Customer Product/Process Change Notification

PCN # 112636  
Issued Date: 29-Dec-23  
Issued By: Jason Yost  
Author: Jason Yost

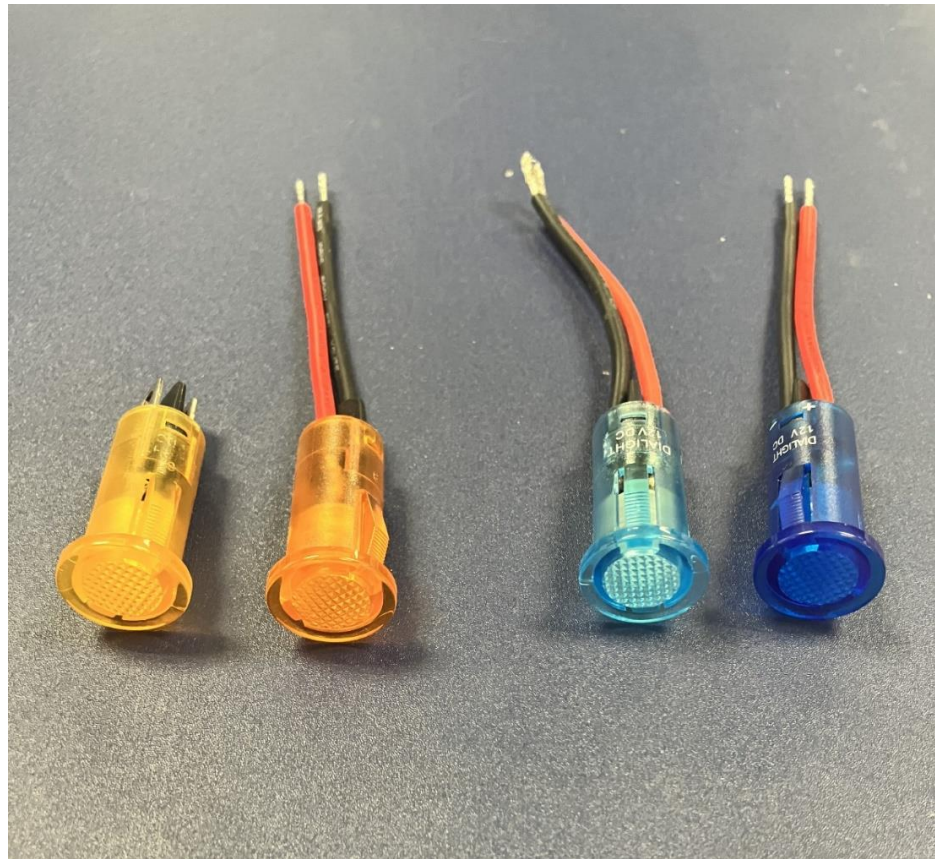
Standardizing Amber and Blue color. Moving to more readily available material.

Need to move to a more readily available resin.

Slightly darker appearance. Same fit, function

Visible difference between parts. Do not mix. Sell old stock before moving to new.
